APPENDIX K: Written Comments Received on Draft Regional Flood Plan and RFPG Responses

**Public Comments Received on Draft Trinity Regional Flood Plan with RFPG Responses
(August 1 - October 10, 2022)**

TWDB Comments on Draft Trinity Regional Flood Plan with RFPG Responses

RE: Texas Water Development Board Comments on Region 03 Trinity RFPG's Draft Regional Flood Plan Contract No. 210792488.

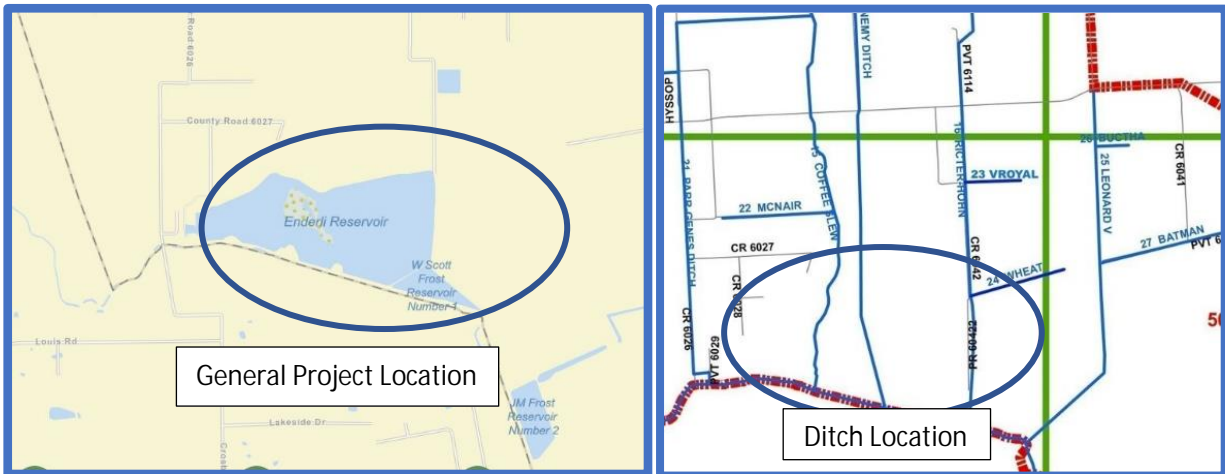
It was a pleasure to meet you at the Trinity Regional Flood Planning Group-Lower Basin Open House on Monday August 29th, 2022. Overall, our group, Liberty County Water Control and Improvement District #1 (WCID#1), was very impressed with the presentation. We are very interested in pursuing a project we think is worthwhile to include in the Regional Flood Plan. We ask your help to study the feasibility of converting an existing reservoir into a retention pond which we believe will solve a long-standing flooding problem for the residents/landowners in this area. See below project location:

Comment #	RFPG Response
5	<p>Information provided by Liberty County Water Control and Improvement District #1 was reviewed by Region 3 RFPG and determined that the level of information provided was sufficient to be considered as a potential FME. However, the location of this particular detention pond falls in the San Jacinto Region (Region 6), not Region 3. The information was relayed to the San Jacinto Regional Flood Planning Group. Region 3 will help follow up with this request with Region 6.</p> <p>If additional actions (FME, FMP, FMS) are sent for consideration, the Region 3 RFPG will determine the Region they belong to and ensure they are considered by the appropriate Regional Flood Planning Group.</p>
6	<p>A significant number of suggestions were provided for the RFPG's consideration. The RFPG discussed many of these concepts during its meetings in 2022. Unfortunately, time constraints did not afford the RFPG the opportunity to delve into these ideas and consider potential unintended consequences or potential liability that were of concern during those discussions. The RFPG may establish a subcommittee in a future cycle of flood planning to review these ideas for potential recommendations, consistent with state, federal and other regulatory bodies, prior to making recommendations for adjustments to the Legislative, Regulatory and Administrative, and/or State Flood Planning process. No changes made.</p>
